Context Sensitive Solutions (CSS) Workshop #2 Meeting Documentation Form

Tuesday, April 7, 2015 from 6-8 pm
Oak Hill United Methodist Church
7815 Hwy. 290 West, 78736

OAK HILL PARKWAY

Context Sensitive Solutions (CSS) Workshop #2

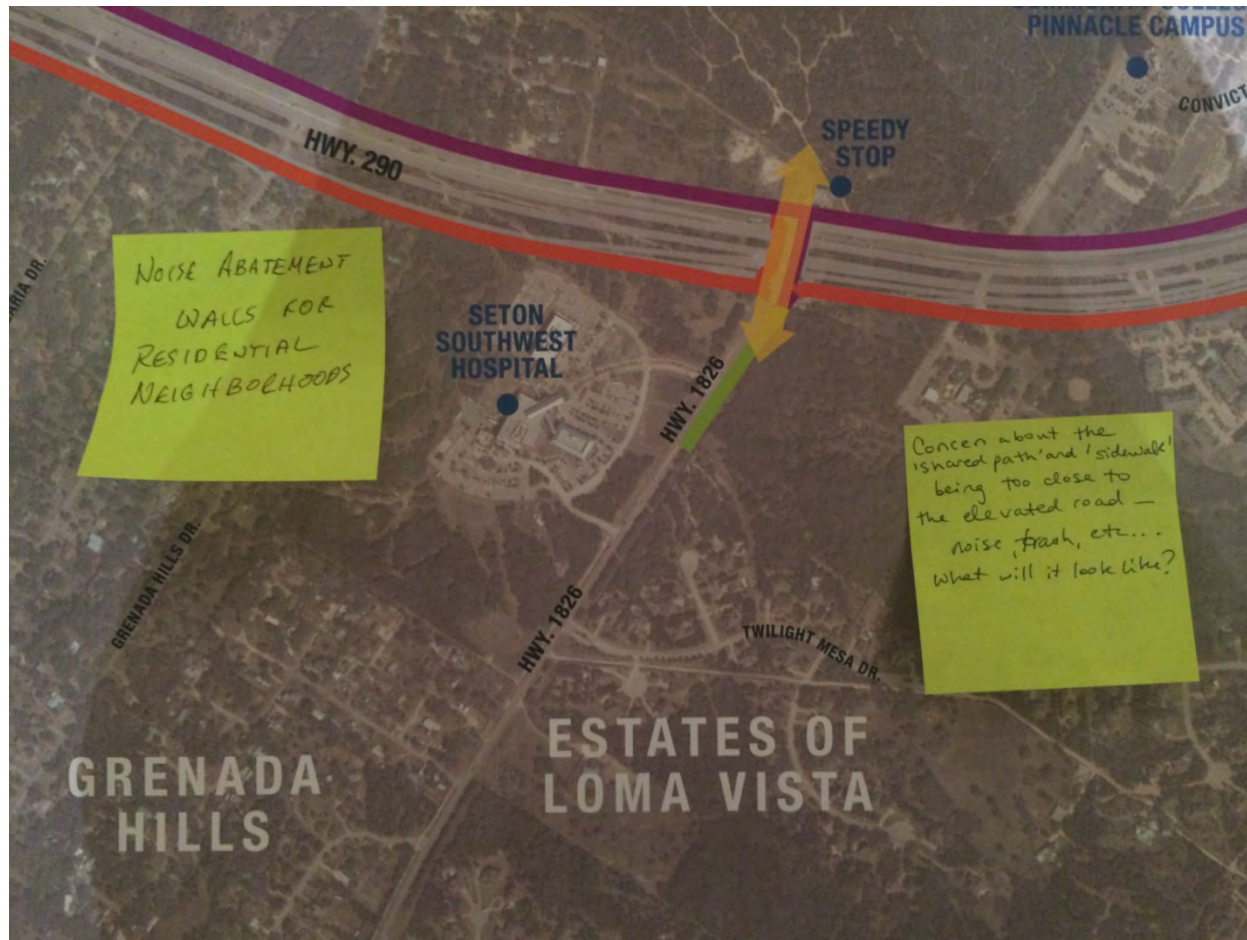
- Extend shared use path on West Hwy 290 down Circle Drive.

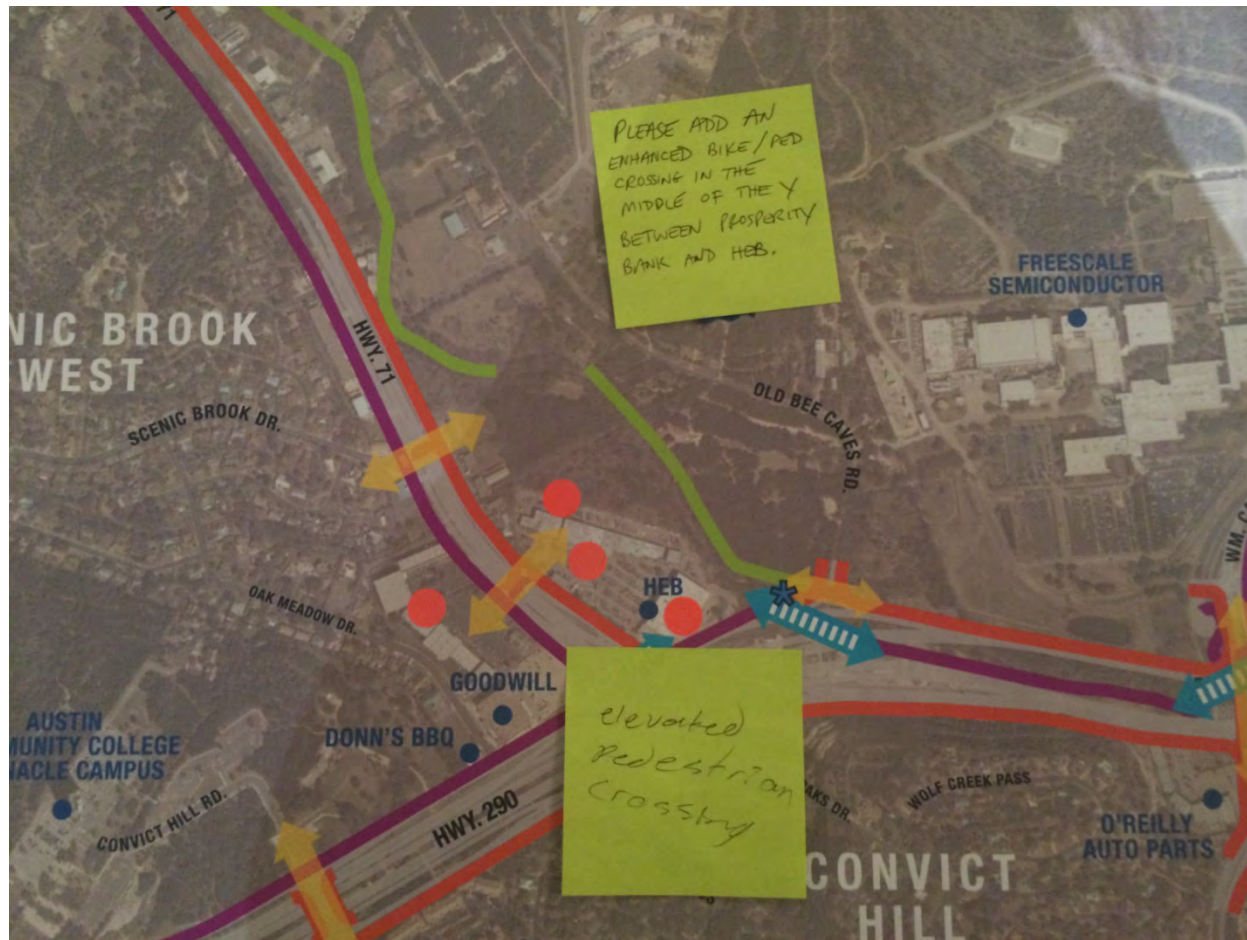
- Noise abatement walls for residential neighborhoods.
- Concern about the shared path and sidewalk being too close to the elevated road – noise, trash, etc. What will it look like?

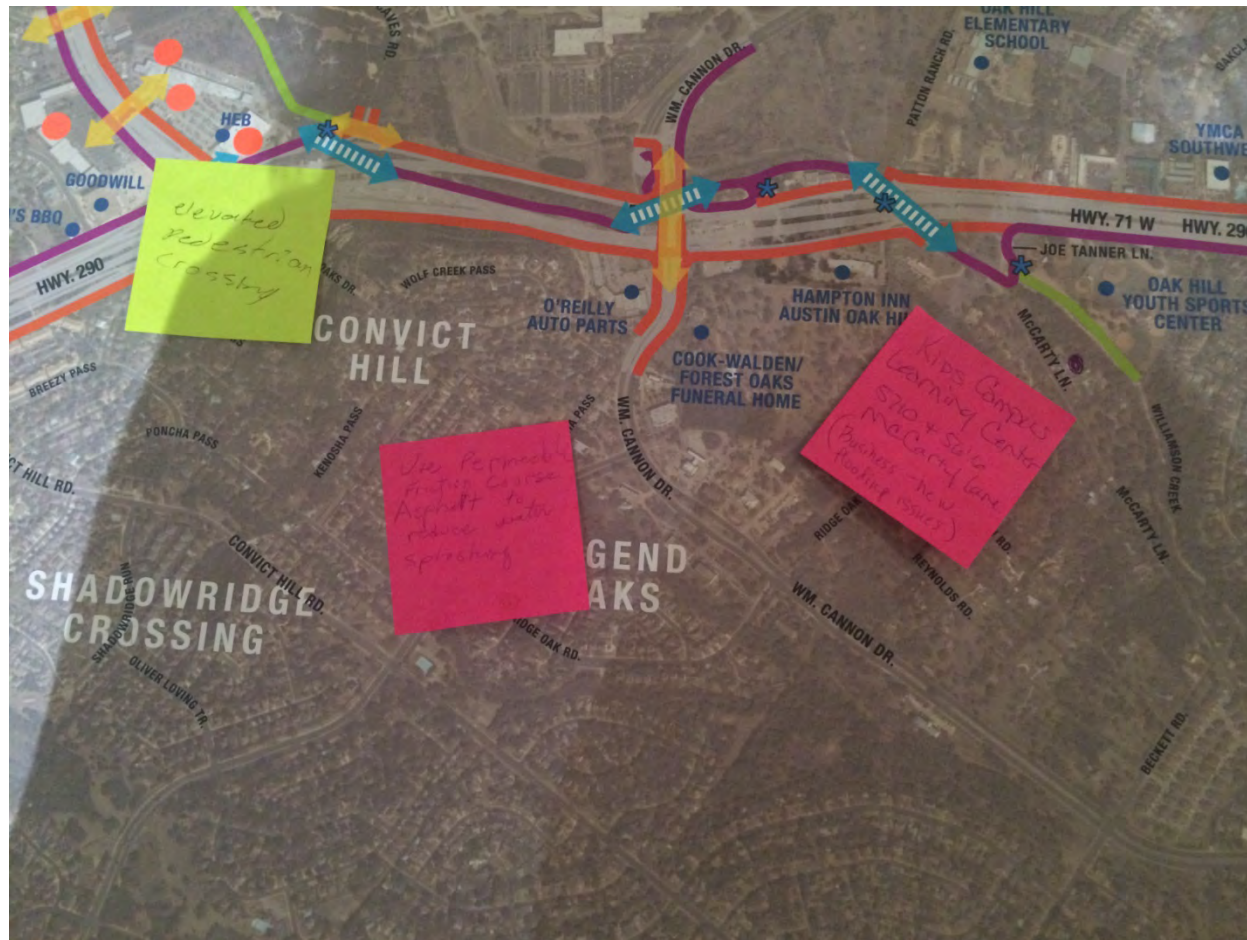
- Please add an enhanced bike/ped crossing in the middle of the Y between Prosperity Bank and HEB.
- Elevated pedestrian crossing.

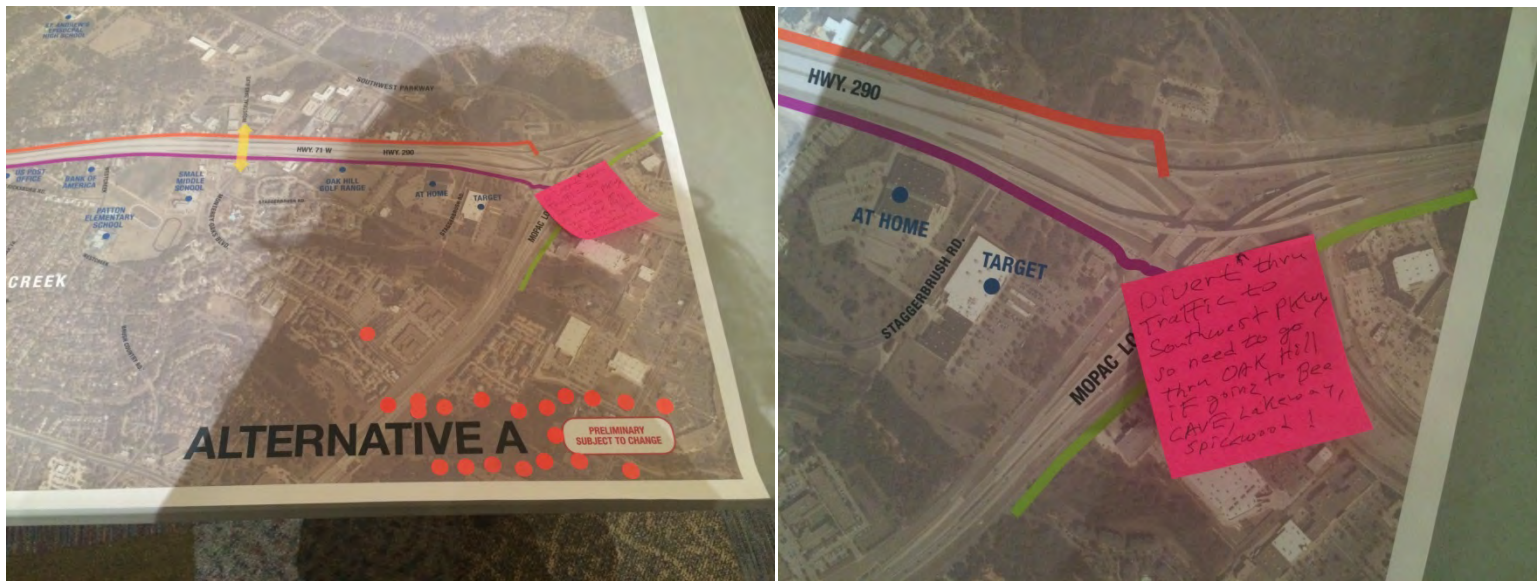
- Elevated pedestrian crossing.
- Use permeable friction course asphalt to reduce water splashing.
- Kids Campus Learning Center 5710 & 5616 McCarty Lane (business – new flooding issues).

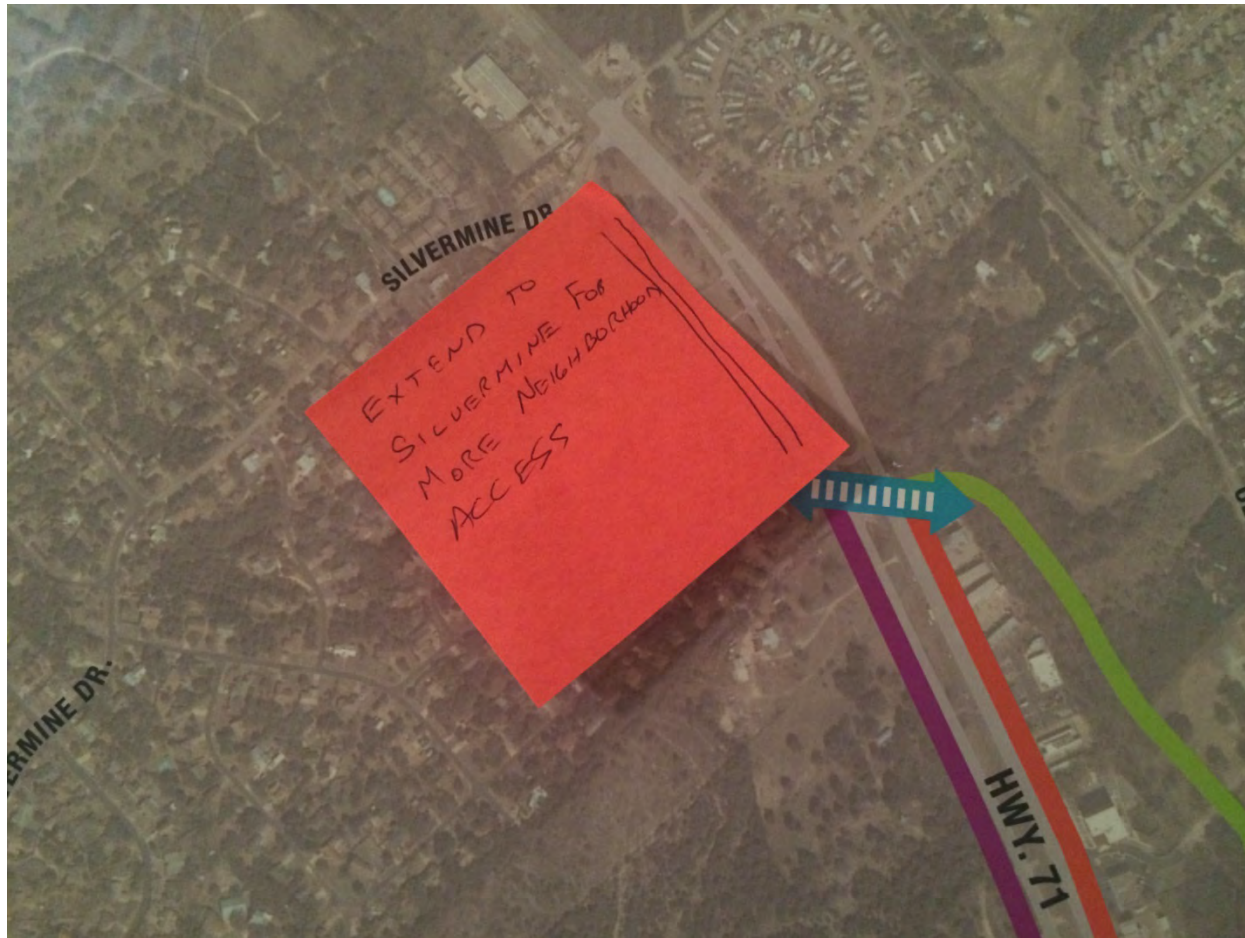
- Extend SUP along Circle Drive to west end at 290.

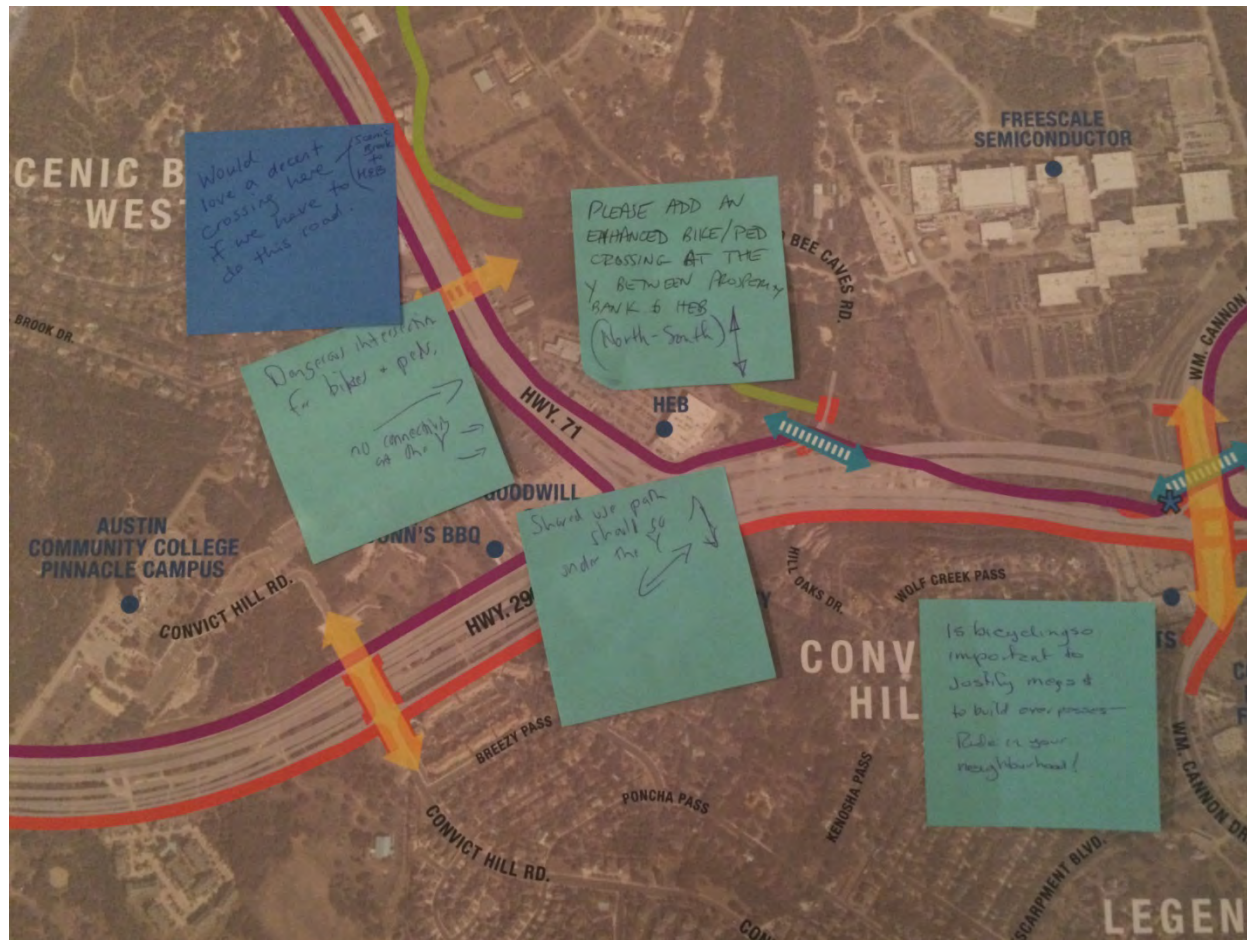
- Extend to Silvermine for more neighborhood access.

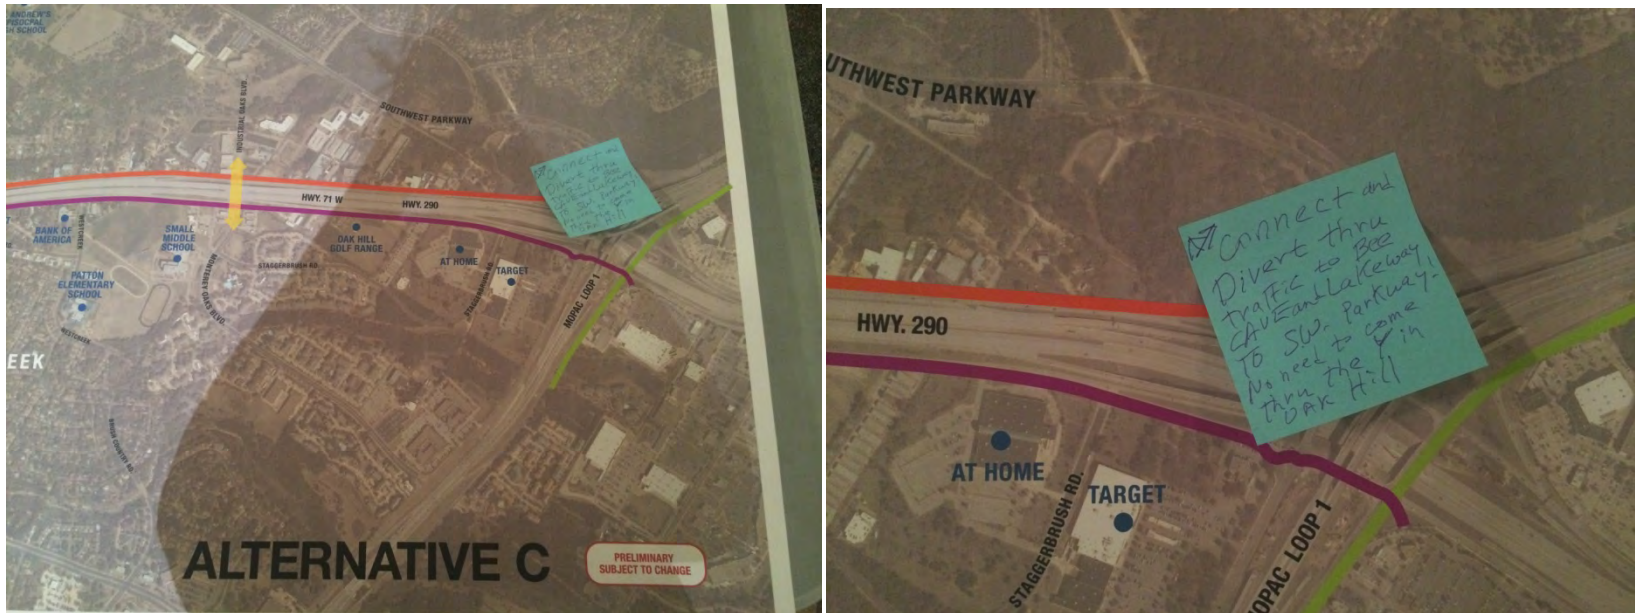
- Would love a decent crossing here if we have to do this road (S?? Bank & HEB).
- Dangerous intersections for bikes and peds. No connectivity at the Y.
- Please add an enhanced bike/ped crossing at the Y between Prosperity Band and HEB.
- Shared use path should go under the Y.
- Is bicycling so important to justify mega money to build overpasses – Ride in your neighborhood!

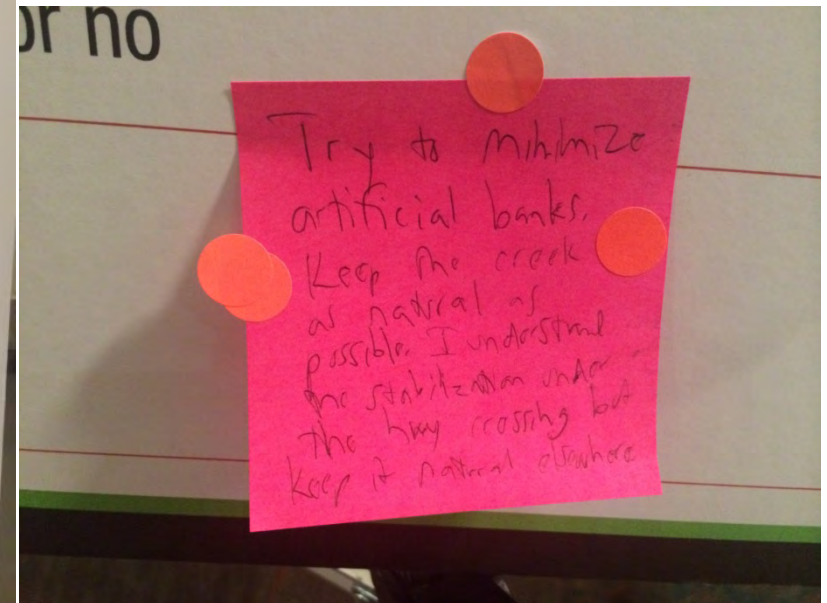
- This depends on how many trees are being removed.

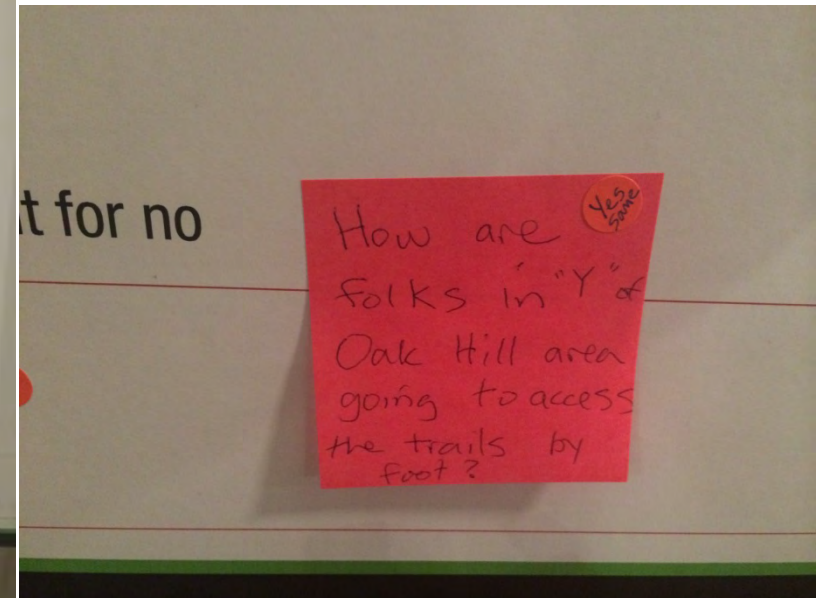
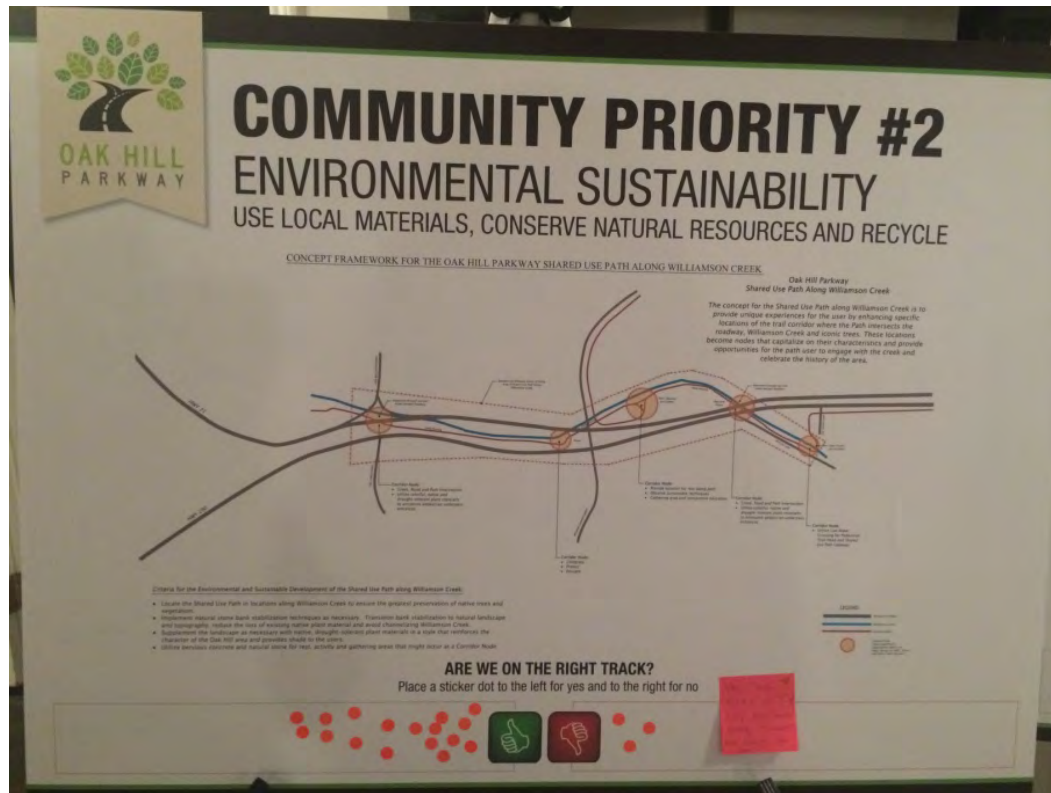
- Try to minimize artificial banks. Keep the creek as natural as possible. I understand one stabilization under the highway crossing, but keep it natural elsewhere.
